Federal Register

[Docket No. FAA-2004-19960; Directorate Identifier 2004-CE-47-AD]

#### Airworthiness Directives; The New Piper Aircraft, Inc. PA-34 Series Airplanes

**ACTION:** Notice of proposed rulemaking (NPRM).

Figure 1

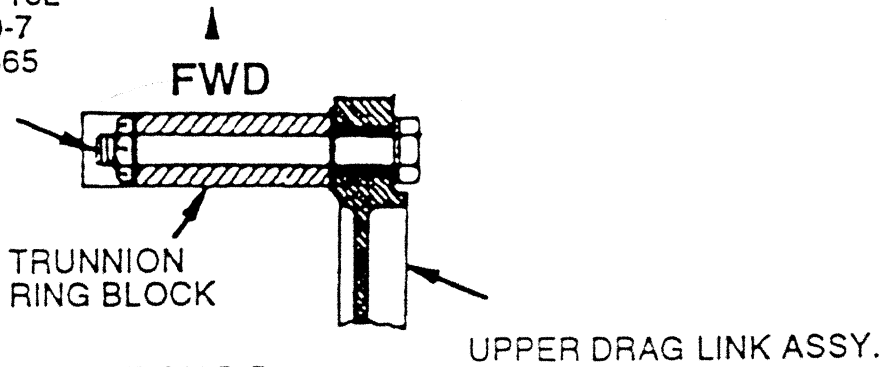
Actions	Compliance	Procedures
(1) Replace the bolt and stack up that connects the upper drag link to the nose gear trunnion with new parts of the following: (i) Piper part number (P/N) 400 274 (AN7-35) bolt; (ii) Piper P/N 407 591 (AN960-716L) washer, as applicable; (iii) Piper P/N 407 568 (AN960-716); (iv) Piper P/N 404 396 (AN320-7) nut; and (v) Piper P/N 424 085 cotter pin.	Within the next 100 hours time-in-service (TIS) after January 28, 1994 (the effective date of AD 93-24-14), unless already done within the last 400 hours TIS before January 28, 1994 (compliance with AD 93-24-14). Repetitively replace thereafter at intervals not to exceed 500 hours TIS. Continue to repetitively replace until the actions in paragraph (e)(2) and (e)(3) of this AD begin.	Follow Figure 1 of this AD.
